| (June 2015) | UNITED STATI DEPARTMENT OF THE BUREAU OF LAND MAN | INTERIOR A refo | Sia OMB Expires: | M APPROVED NO. 1004-0137 January 31, 2018 | |
|--|---|--|--|---|--|
| SUNE | ORY NOTICES AND REP | ORTS ON WELLS | 5. Lease Serial No. NMNM17056 | | |
| 2. Name of Operator XTO ENERGY INC | Contact: E-Mail: kelly_kan | KELLY KARDOS dos@xtoenergy.com | 9. API Well No. 30-015-45495 | 9. API Well No. 30-015-45495 | |

XTO Energy Inc. Nash 202 Projected TD: 21100' MD / 9317' TVD SHL: 90' FNL & 630' FEL , Section 19, T23S, R30E BHL: 1276' FSL & 990' FEL , Section 6, T23S, R30E

PECOS DISTRICT DRILLING CONDITIONS OF APPROVAL

| This drawing is the property of GE Oil & Gas Pressure Control LP and is considered confidential. Unless otherwise approved in writing, neither it nor its contents may be used, copied, transmitted or reproduced except for the sole purpose of GE Oil & Gas Pressure Control LP. | хто | DENERGY | , INC. |
|--|--|---------|---------|
| 13-3/8" x 9-5/8" x 5-1/2" 10M RSH-2 Wellhead | DRAWN | VJK | 16FEB17 |

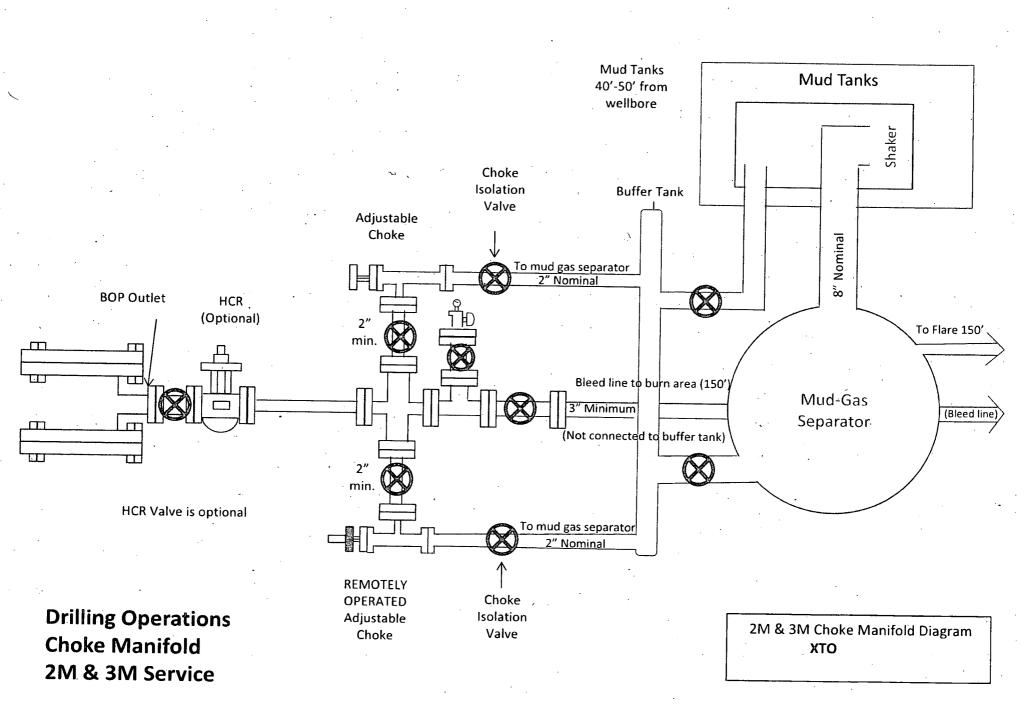
Permanent Wellhead – GE RSH Multibowl System

A. Starting Head: 13-5/8" 5M top flange x 13-3/8" SOW bottom

B. Tubing Head: 13-5/8" 5M bottom flange x 7-1/16" 10M top flange

- · Manufacturer will monitor welding process to ensure appropriate temperature of seal.
- Operator will test the 9-5/8" casing per BLM Onshore Order 2
- Wellhead Manufacturer representative will not be present for BOP test plug installation

- 4. Operator has proposed a multi-bowl wellhead assembly. This assembly will only be tested when installed on the 13-3/8 inch casing. Minimum working pressure of the blowout preventer (BOP) and related equipment (BOPE) required for drilling below the 13-3/8 inch casing shoe shall be 3000 (3M) psi.

- a. Wellhead shall be installed by manufacturer's representatives, submit documentation with subsequent sundry.
 - b. If the welding is performed by a third party, the manufacturer's representative shall monitor the temperature to verify that it does not exceed the maximum temperature of the seal.

- c. Manufacturer representative shall install the test plug for the initial BOP test.
 - d. Operator shall perform the 9-5/8 inch intermediate casing integrity test to 70% of the casing burst. This will test the multi-bowl seals.
